Project: HAMILTON-WENTWORTH DISTRICT SCHOOL BOARD
P02083
BALLARD WASHROOMS & CHANGE ROOM RENOVATIONS &
UPGRADES

P02083 W.H. BALLARD ELEMENTARY SCHOOL **HWDSB**

ADDENDUM No. S1

April 23, 2025

PARTIAL HEIGHT BLOCK REINFORCEMENT
SCALE: N.T.S.

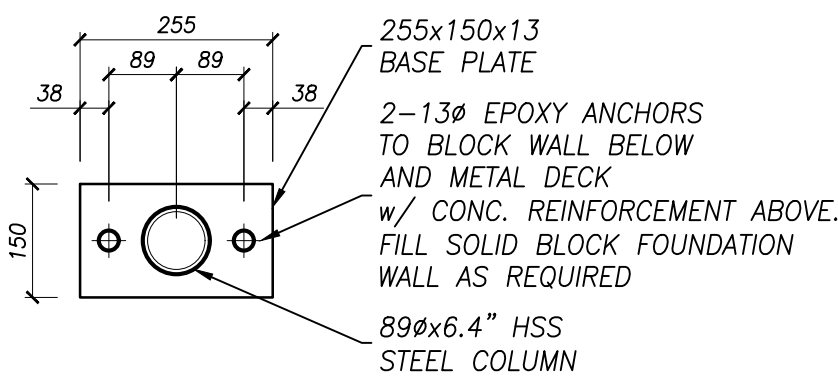
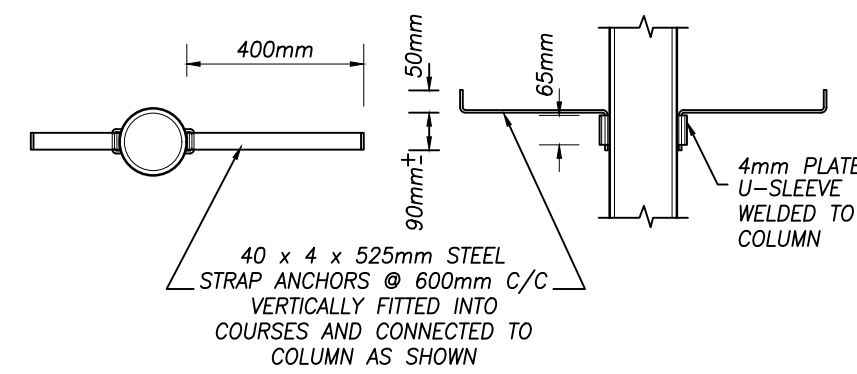
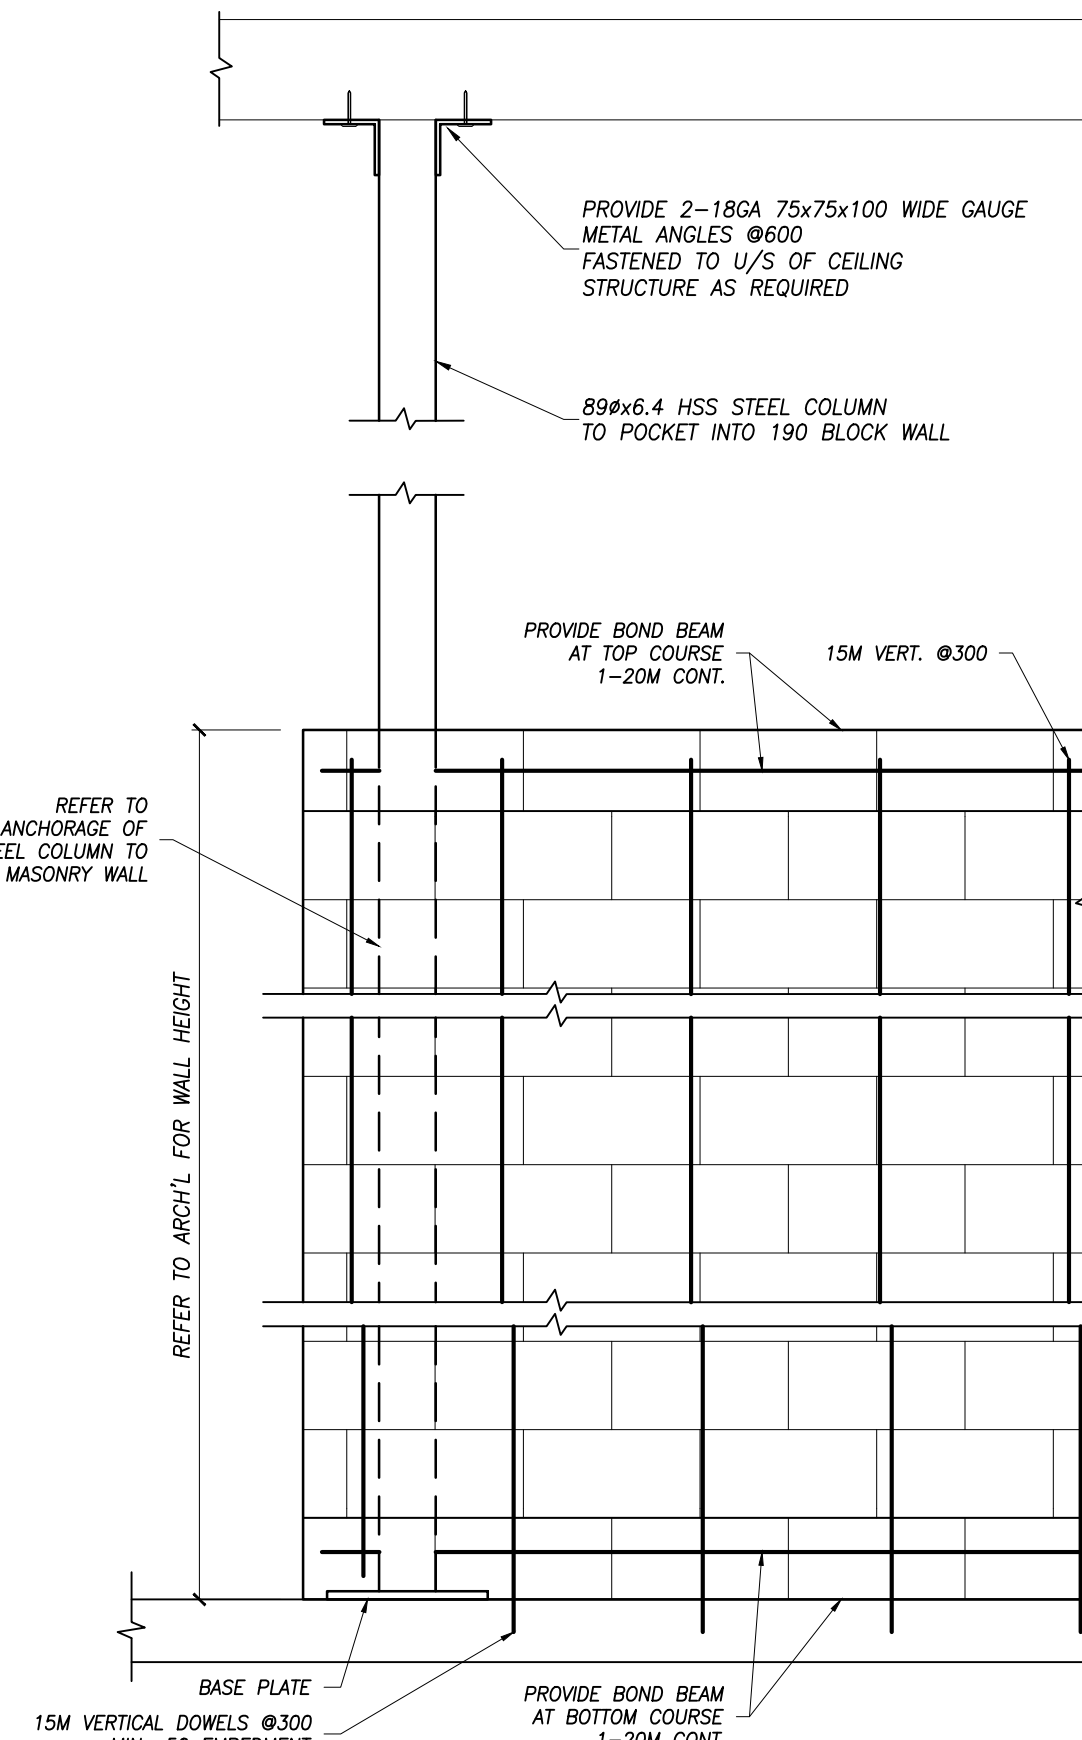
D. Drawings S4.01

- a) Additional details provided for partial height non-load bearing block walls
